REVISIONS:
 1 Permit Correction June 30, 2023

PROJECT TITLE:
Sno-Valley Senior Housing

SHEET TITLE:
Foundation Plan

Reviewed for
2018 Building Code Compliance
Lou Fyler
8/17/23
Building Plan Review by
402 15th Avenue East
Seattle, Washington 98114
phone: 206.329.8300
fax: 206.329.5494

S2.1

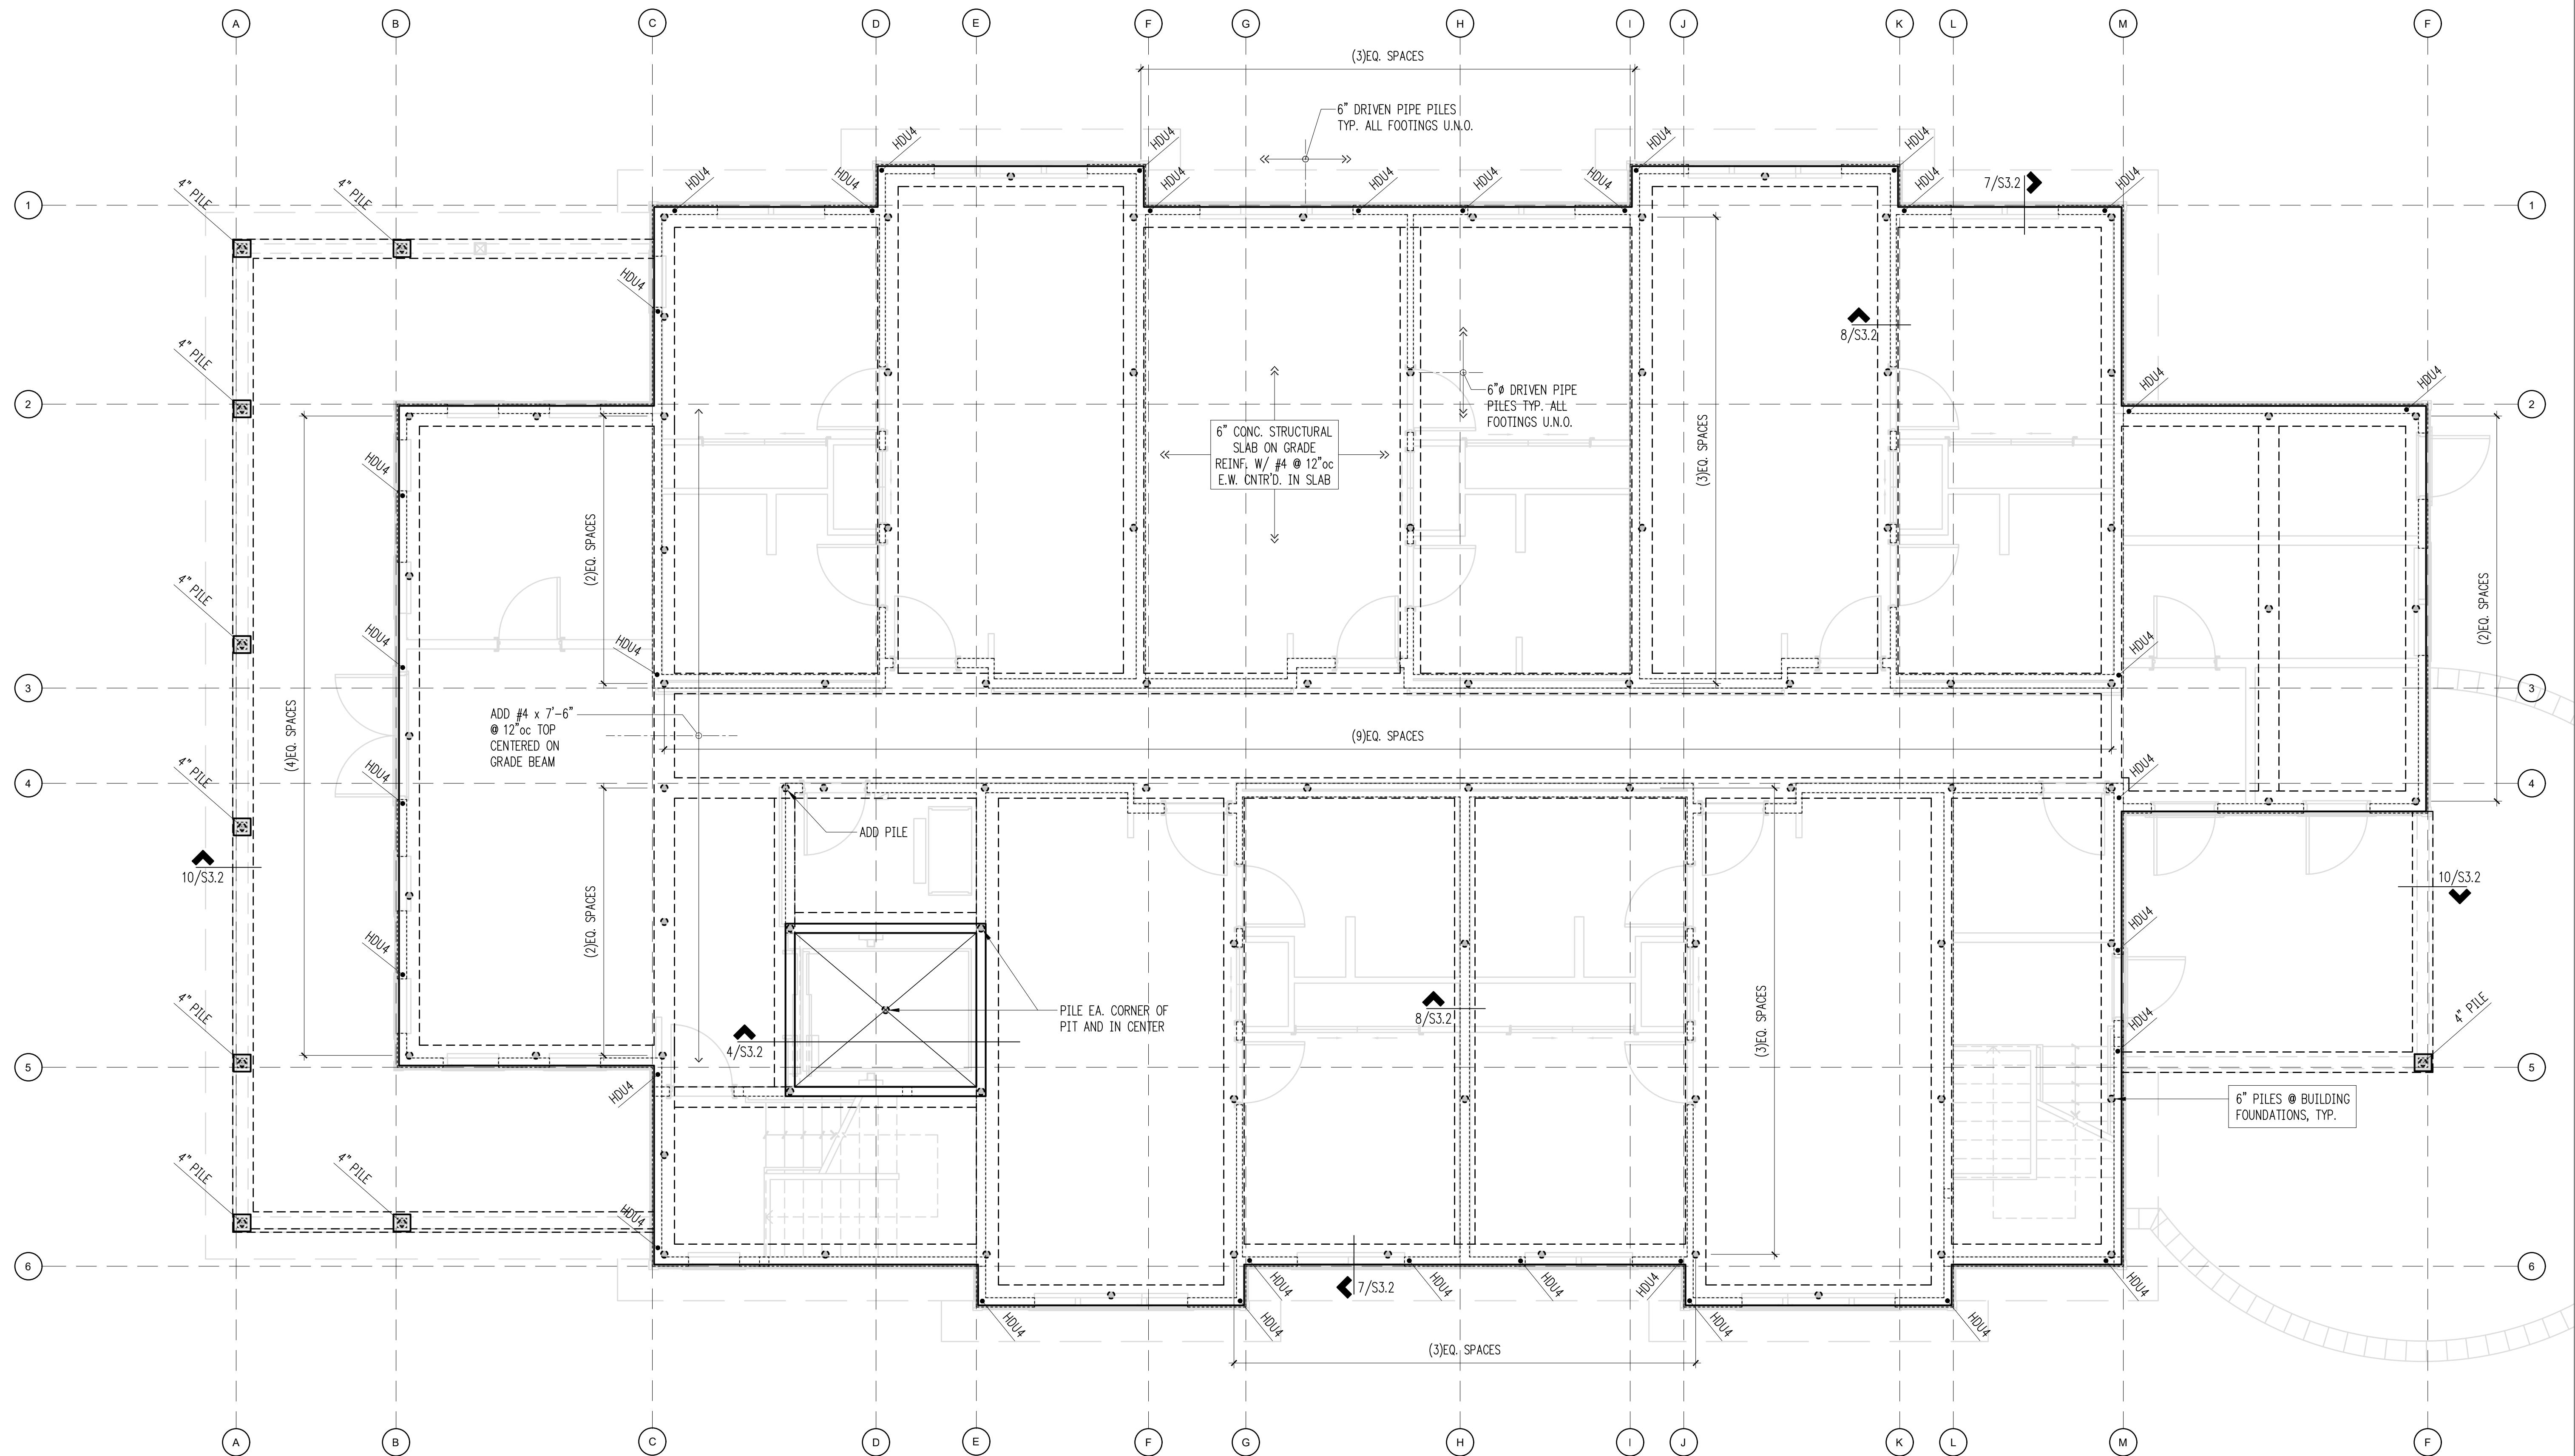
USE ONLY 6" PILES PER ENG CALCS PAGE 11

Typical Pipe Pile Assembly

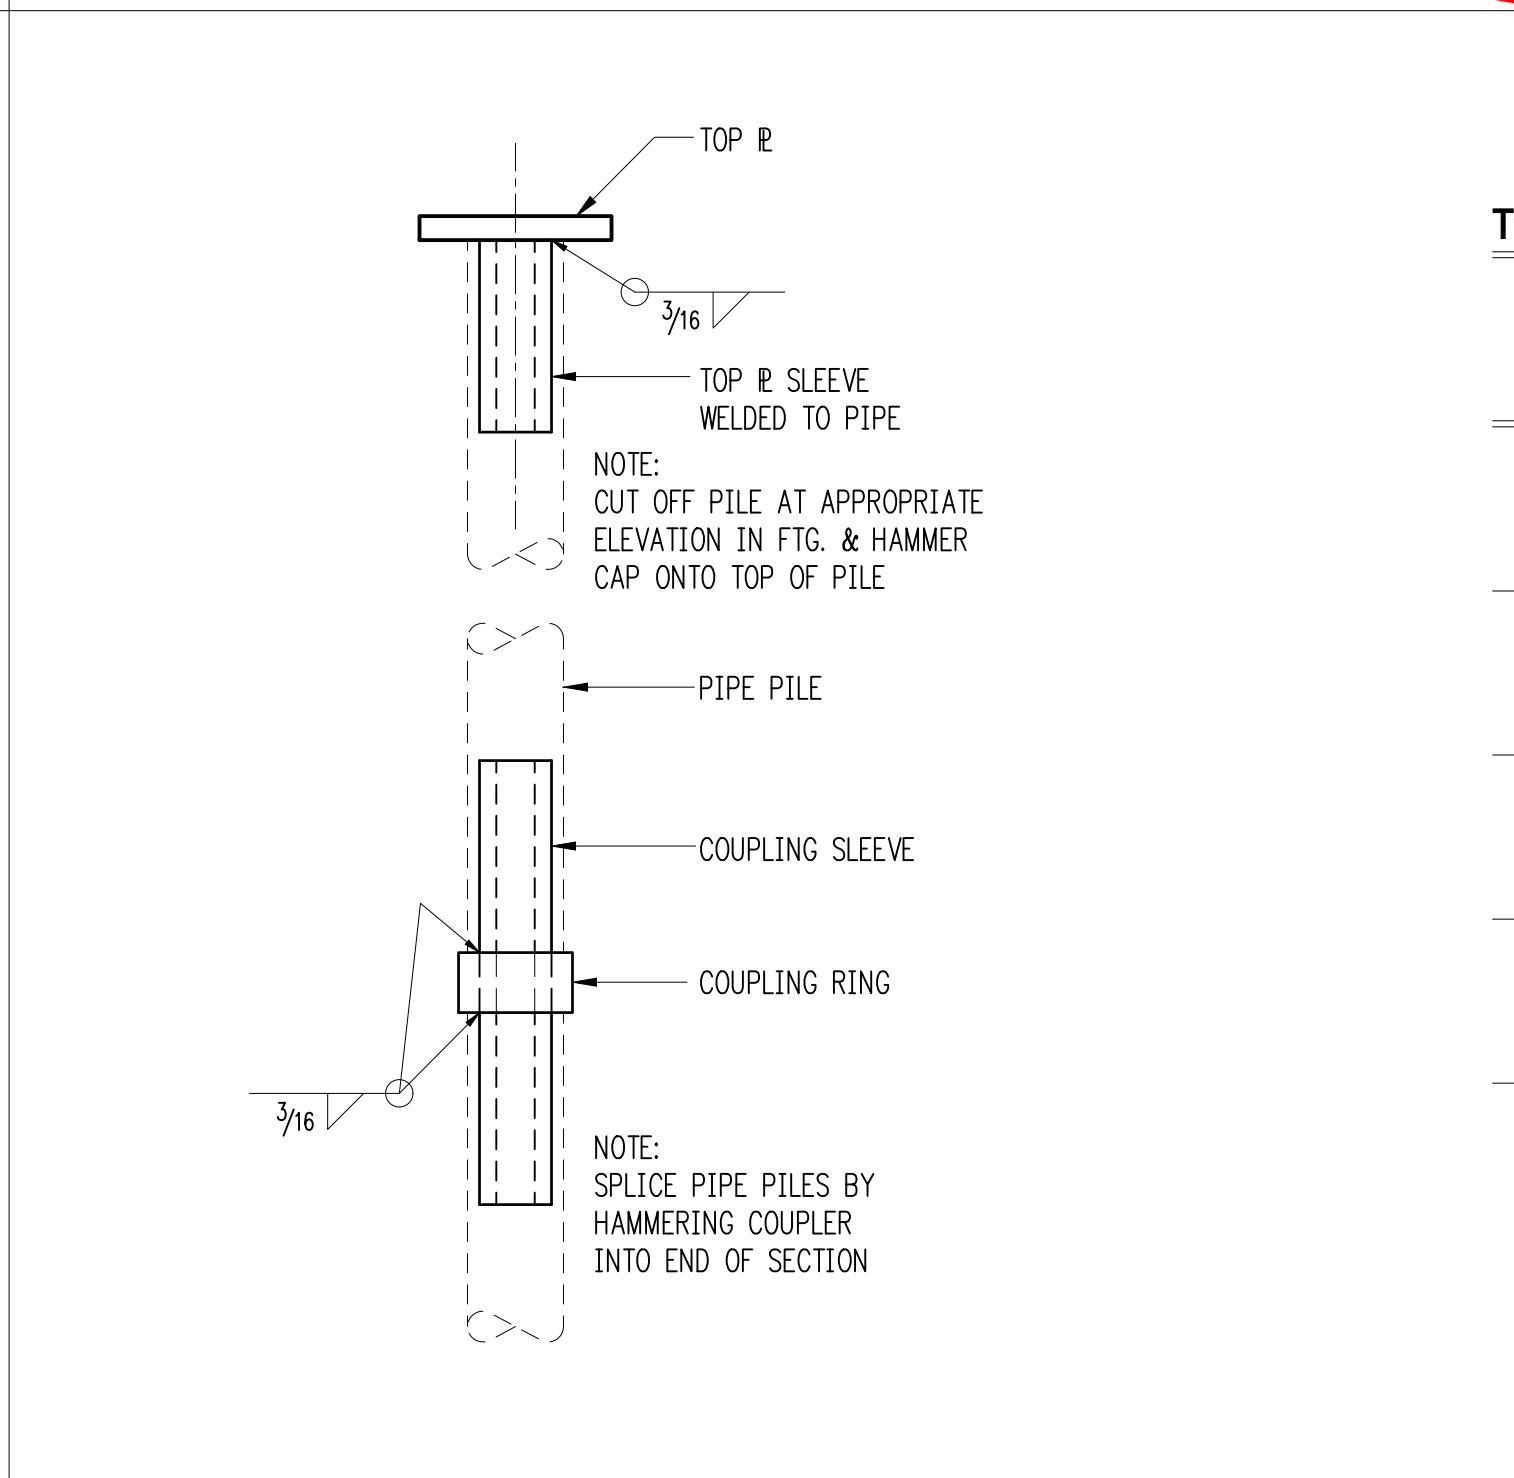
USE 6" PER CALCS

Typical Top Plate Splice 5

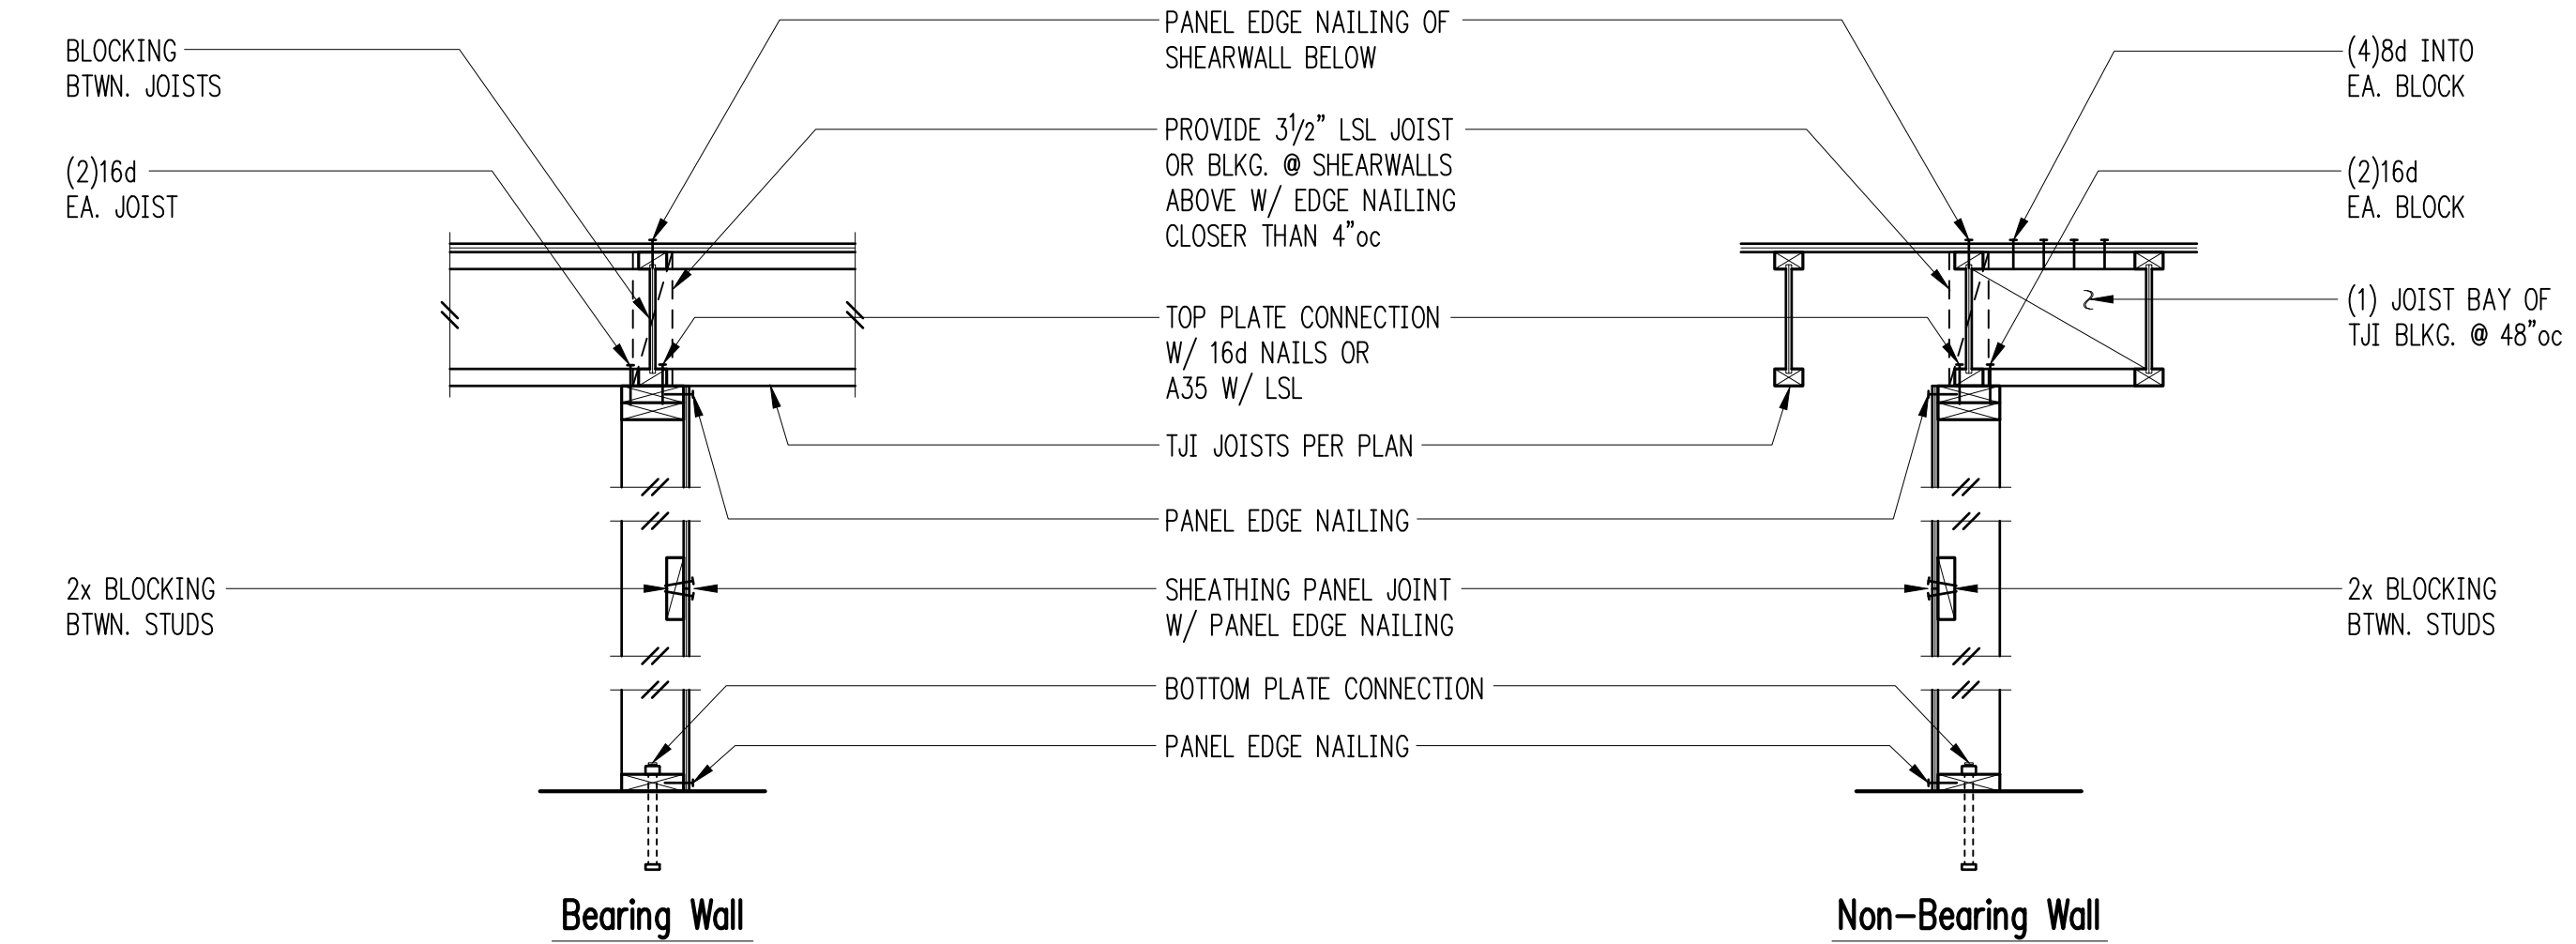
USE MIN 1/2" CDX PLYWOOD PER PAGE 8 OF STRUCTURAL CALCULATIONS
